Subject: ACCESSORY ILLUMINATED DOOR SILL PLATE INSTALLATION INSTRUCTIONS CORRECTION	Service Alert No.: SA-027/22
	Last Issued : 06/09/2022

2023 CX-50

CLIP ORIENTATION

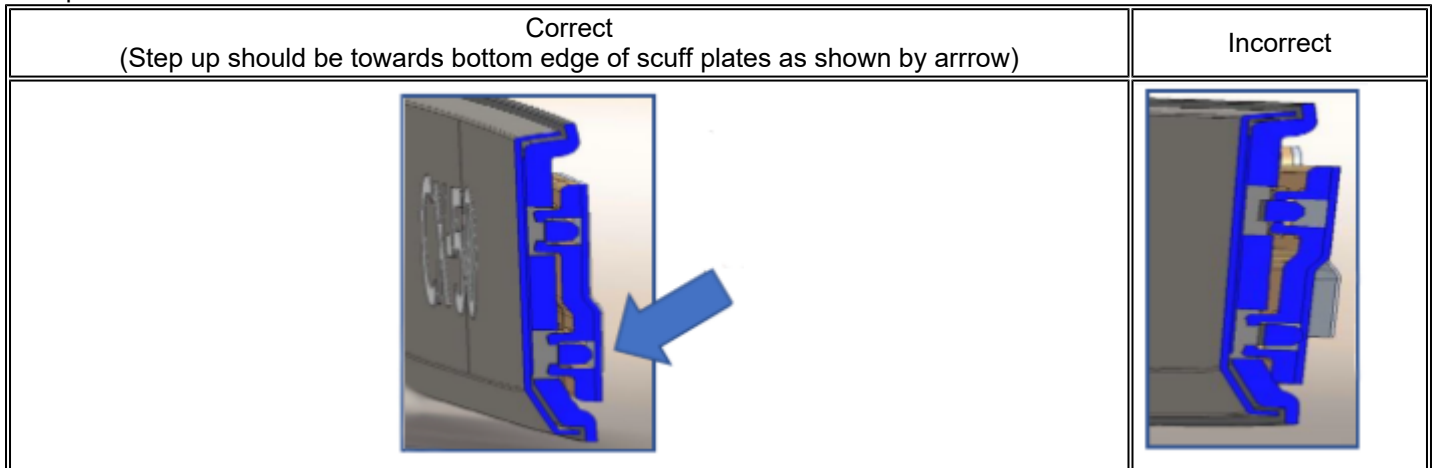
1. Remove both left and right front scuff plates from the foam sleeve.
2. Turn over and observe the orientation of the attachment clips located on the backside of the parts.

3. Clips should be oriented as shown below.

4. If clips are in the wrong orientation, remove them from the scuff plate and reinstall them in the correct orientation.

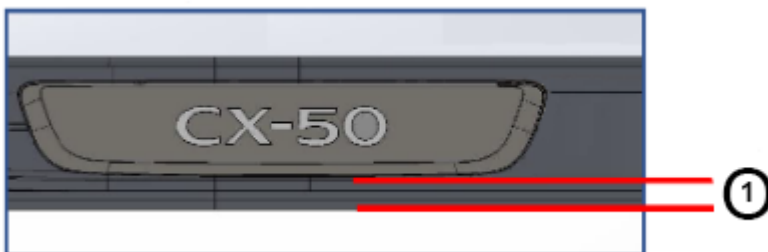
1. During Step 3 of the installation instructions, in addition to the items already mentioned, also remove the original side plastic trim.
2. Check that the scuff plate is parallel with the frame edge (1).
